AMENDED PLAN

SHOWING PROPOSED BUNGALOW

ON PLOT N° 9/6 SHEET J.M.3

With reference to your application dated *19/6* 19*30*,
with a plan for the proposed building/additions and alterations on plot
No. *4/6*, Survey Shee No. *7m-3* *Jan Shad* quarter
I have the honour to inform you that until the following requirements
are complied with plans cannot be passed:—

SECTION ON C.D.

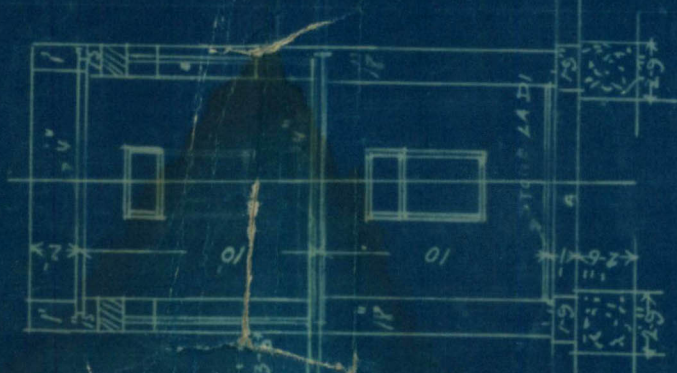
1) The level line is drawn through the existing portion and the portion proposed construction on 1st floor and so a portion of it is shown red in section.

- (1) *10' space must be left from the sides.*
- (2) *The section line is wrongly shown.*
- (3)
- (4)
- (5)
- (6)
- (7)
- (8)
- (9)
